U.S. Nuclear Regulatory Commission

MAY 08 1991

ENCLOSURE 1

NRC FSAR MEETING
Seismic and Civil Issues Program

Figure A-16 SSE TORSIONAL MOMENT COMPARISON

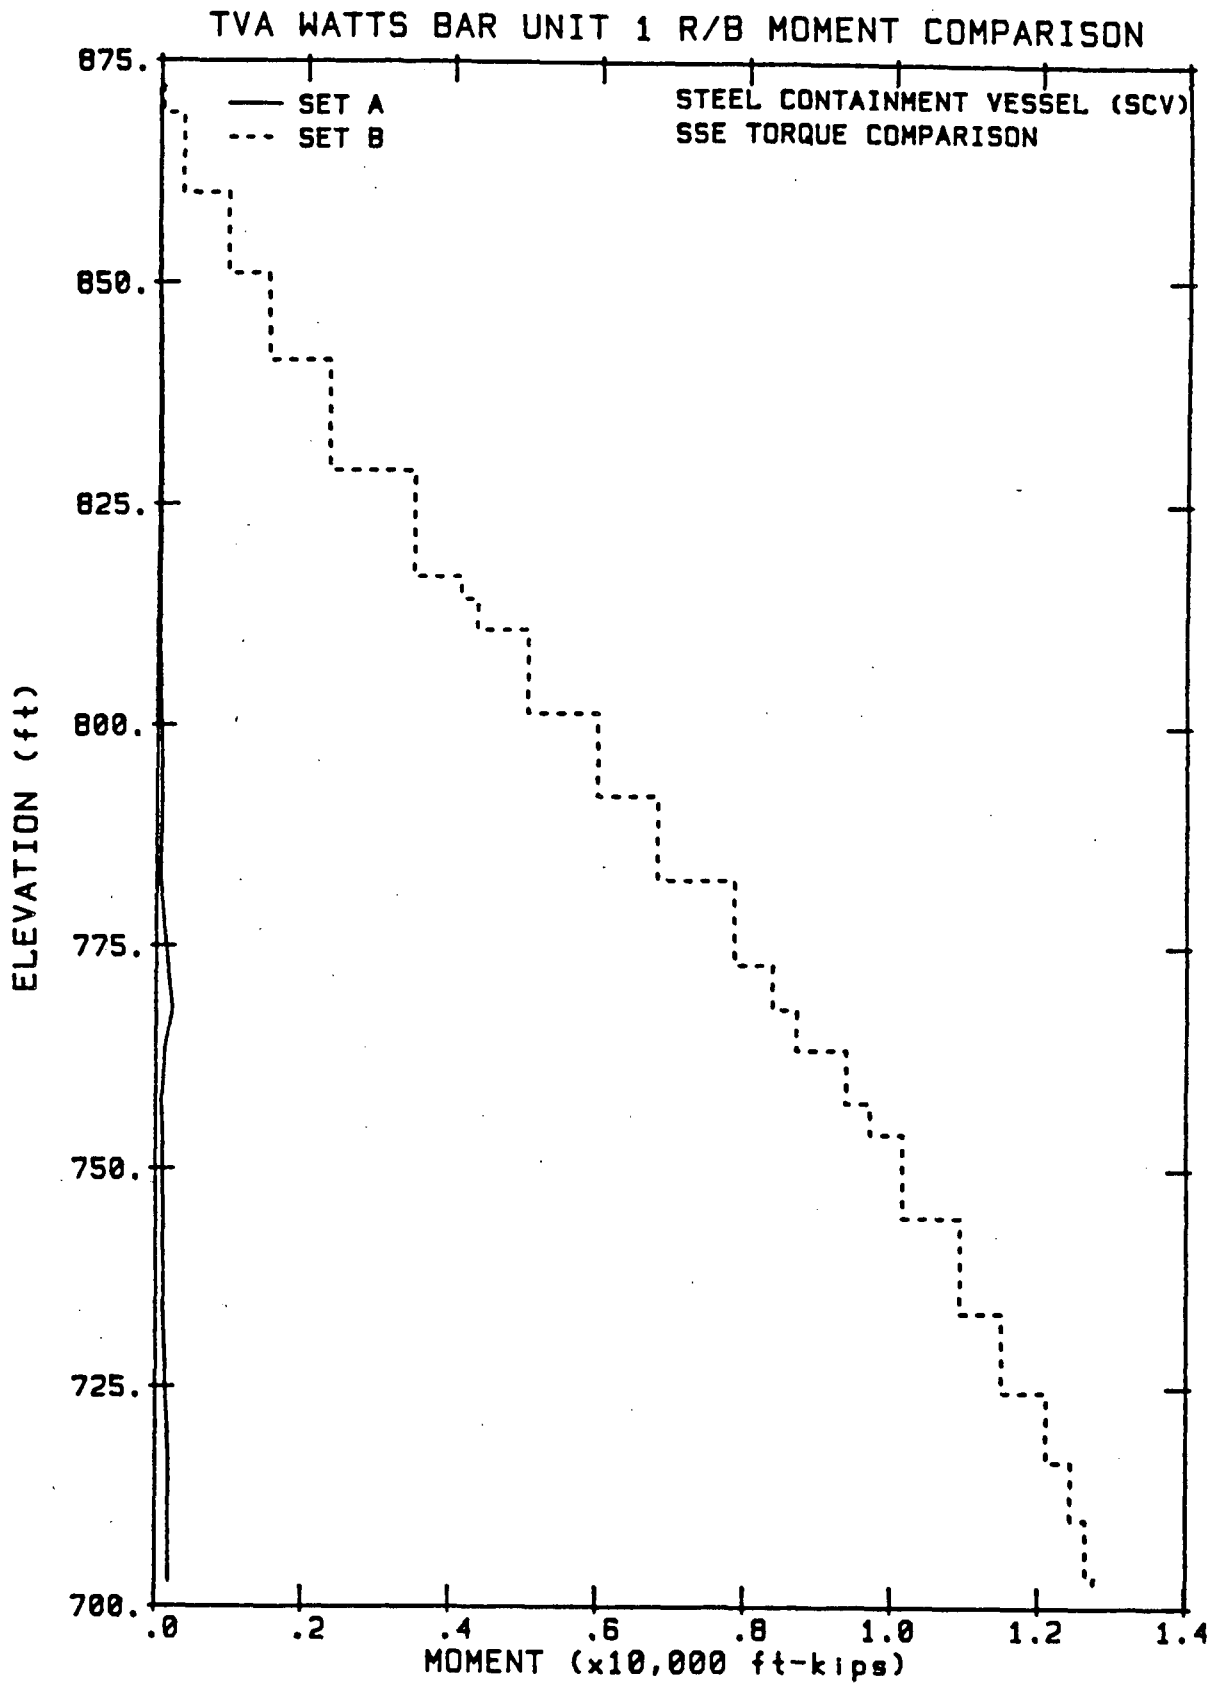
Verify whether or not mass eccentricities were actually included in the Set B and Set C analysis model for the Steel Containment Vessel.

The comparison of Set A and Set B torsional moments, shown in figure A-16 (attached) of RIMS #B26 900801 162, confirmed that the actual eccentricities have negligible effects on Set B and Set C results. WJA 5/1/91

WATTS BAR - TYPICAL CONDUIT SUPPORT TYPES

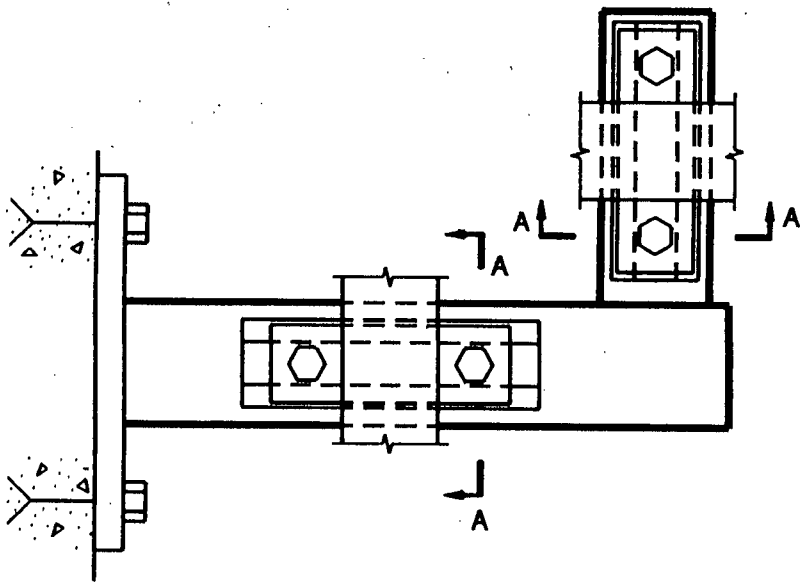
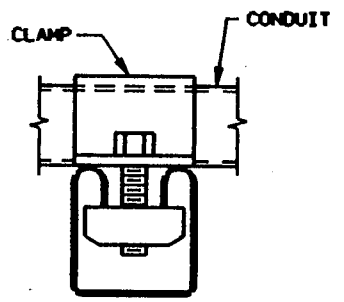
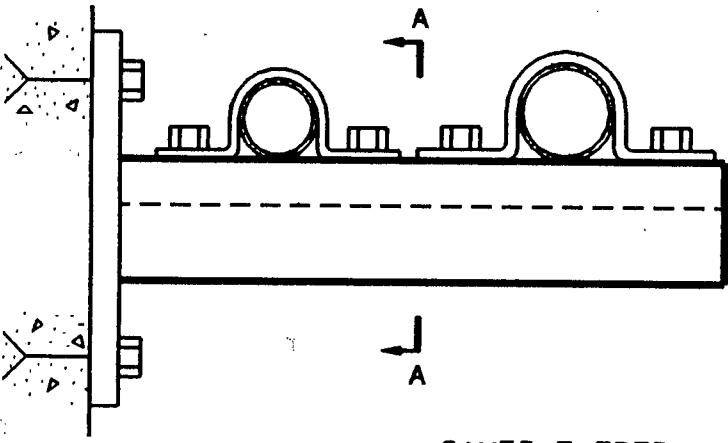
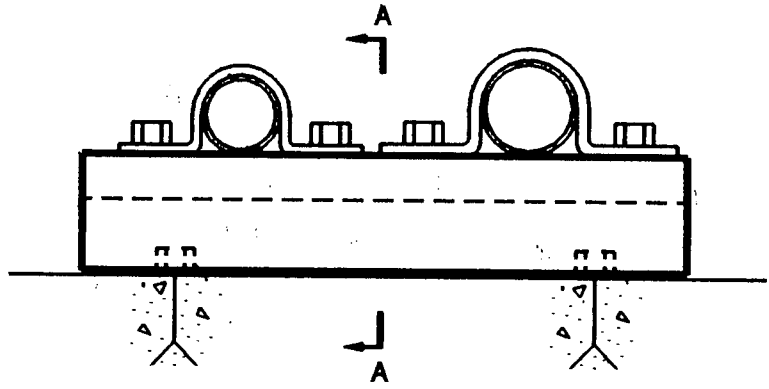
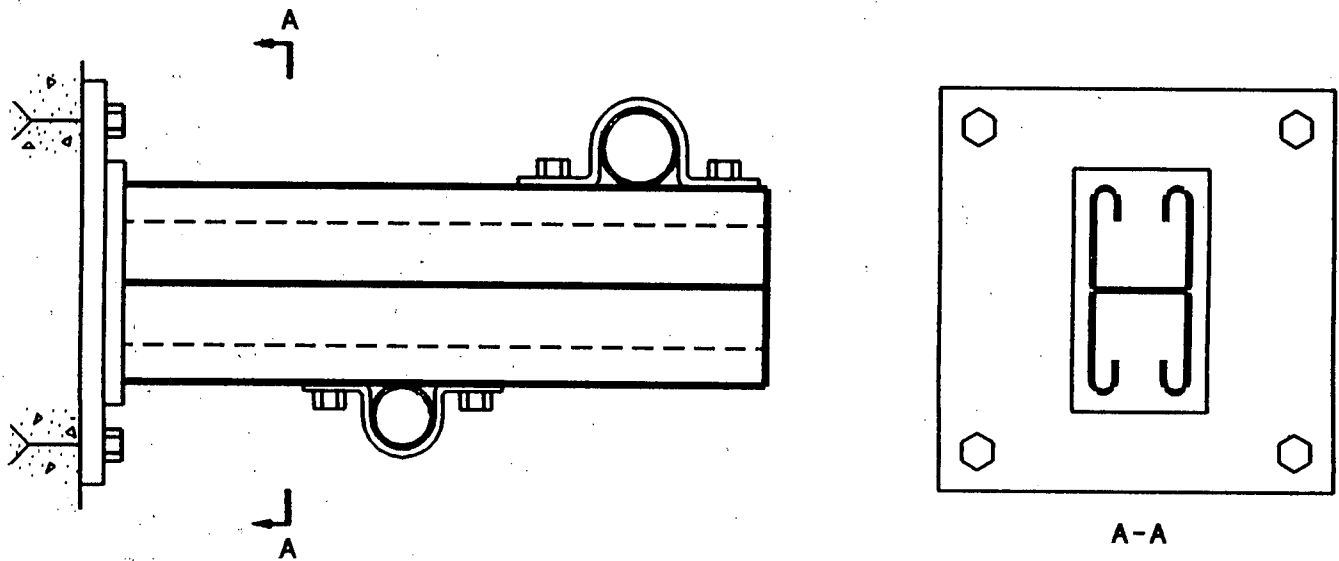
Numerous questions to be clarified by TVA. Basis for using average damping values needs justification. Tests by Wyle and ANCO correspond to lower values.

Several licensed plants use conduit damping values equivalent to those proposed for WBN. Design parameters for five of those plants (Byron, Braidwood, Clinton, Grand Gulf, and Vogtle) were obtained and compared with those at WBN and summarized in the attached table.

As shown in the attached table, WBN conduit systems are comparable to those five plants currently licensed to 4%/7% damping levels. The proposed damping for WBN is therefore justified and supported by these precedents.
